R44

SERVICE BULLETIN SB-11

SUBJECT: Replacement of Carburetor Air Temperature Gage and Relocation of Probe.

ROTORCRAFT AFFECTED: All R44 Helicopters S/N 0001 thru 0201

FIGURE 1

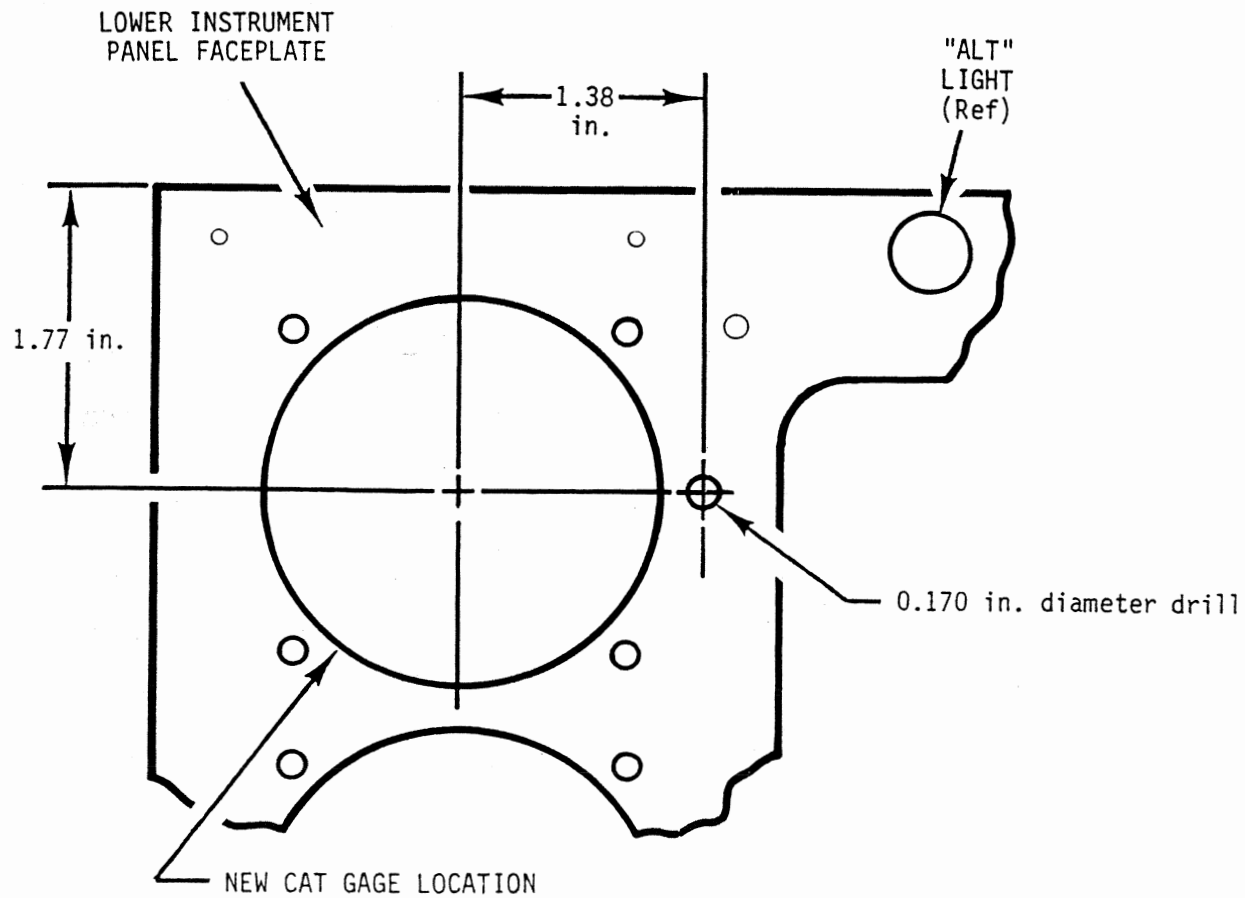
- 1) Remove two screws securing instrument console and tilt console back. Cut ty-raps securing CAT gage wires and remove gage.
- 2) One wire in the aircraft wiring harness must be repositioned within the CAT gage harness connector. Using the tool provided, gently remove wire #36 from the #2 position in the connector and insert it firmly into the #3 position.
- 3) Install new C604-6 gage, ty-rap wires and install console screws.
- 4) Verify CAT gage and OAT gage read approximately the same when engine is cold.

- 1) Remove two screws securing instrument console and tilt console back. Cut ty-raps securing wires for CAT gage and clock and remove both instruments.
- 2) One wire in the aircraft wiring harness must be repositioned within the CAT gage harness connector. Using the tool provided, gently remove wire #36 from the #2 position in the connector and insert it firmly into the #3 position.
- 3) Drill new CAT gage post light hole per dimensions in Figure 1. Remove paint around hole on backside of face plate for post light ground. Install B195-1 post light and connect post light wire to instrument cluster light stud.
- 4) Install new C604-6 gage in upper console hole and install clock in lower console hole. Connect and ty-rap wires to wire bundle and install console screws.
- 5) Verify proper function of post light and that CAT gage and OAT gage read approximately the same when engine is cold.
